**Docket Item #11**  
**Development Site Plan 2008-0017**  
**Encore Apartments Clubhouse**  
**4615 Seminary Road and 4550 West Braddock Road**

<b>Application</b>	<b>General Data</b>	
<b>Project Name:</b> Encore Apartments Clubhouse Renovation	PC Hearing:	April 7, 2009
	If approved, DSUP Expiration:	April 18, 2012 (36 Months)
	Plan Acreage:	Parcel 500: 380,437 SF (8.73 ac) Parcel 501: 361,229 SF (8.29 ac) Total: 741,666 SF (17.03 ac)
<b>Location:</b> 4615 Seminary Road and 4550 West Braddock Road	Zone:	RB/Townhouse Zone R8/Single Family Zone
	Proposed Use:	Pool House Addition
	Dwelling Units:	0
	Gross Floor Area:	7,087 SF
<b>Applicant:</b> Clark Seminary Forest, LLC and BPMS Seminary Forest c/o Bonaventure Realty Group by M. Catharine Puskar, attorney	Small Area Plan:	Seminary Hill/Strawberry Hill
	Historic District:	NA
	Green Building:	NA

**Purpose of Application:** The applicant is proposing to renovate an existing pool house, construct a 7,087 square foot two-story addition to the pool house and create 21 additional parking spaces. Sixteen spaces are proposed in an area currently occupied by an antiquated central plant and cooling tower – both of which are proposed to be demo

*Figure 2: Proposed Parking Area #1*

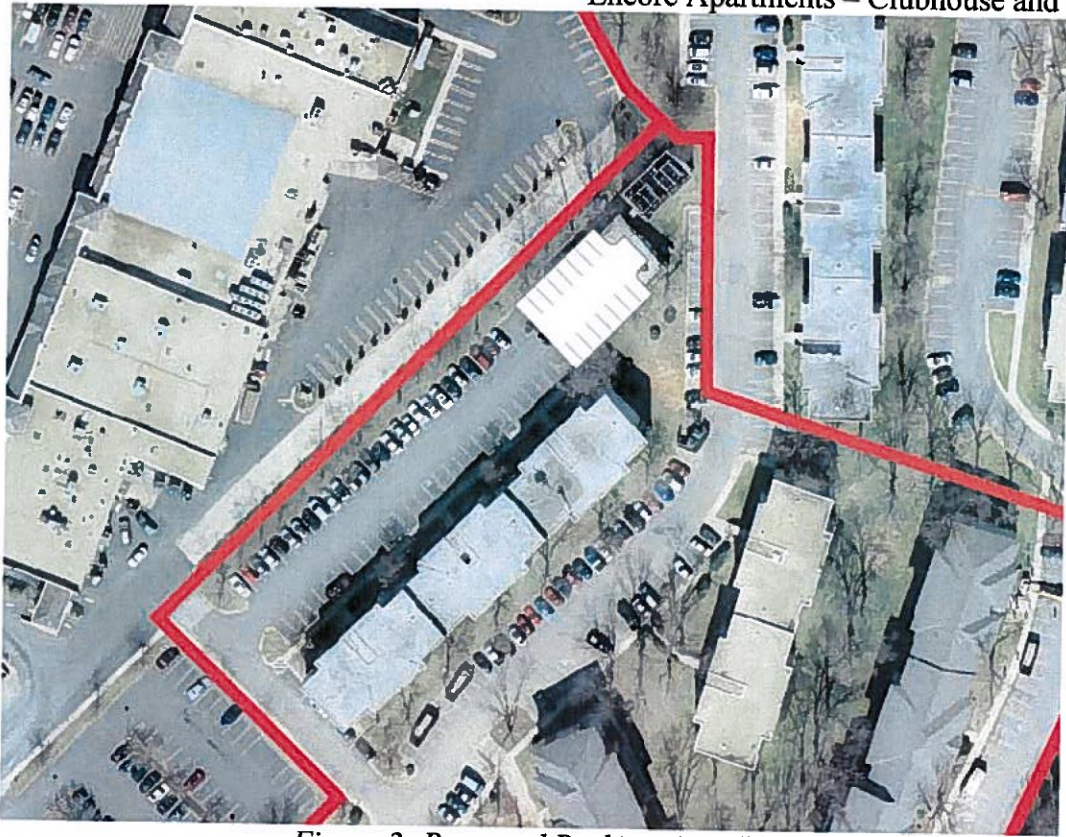
- a. The applicant shall install and maintain ADA accessibility to and from the newly developed parking lot adjacent to the clubhouse.
  - b. A sidewalk shall be extended along the eastern side of parking area #1 to the full length of the revised parking lot.

- b. The applicant shall provide tree plantings to extend to the existing trees in parking area #1. (P&Z)(RP&CA)
4. The applicant shall develop, provide, install and maintain an integrated Landscape Plan that is coordinated with other associated site conditions to the satisfaction of the Directors of RP&CA, P&Z, and T&ES. At a minimum the Landscape Plan shall:
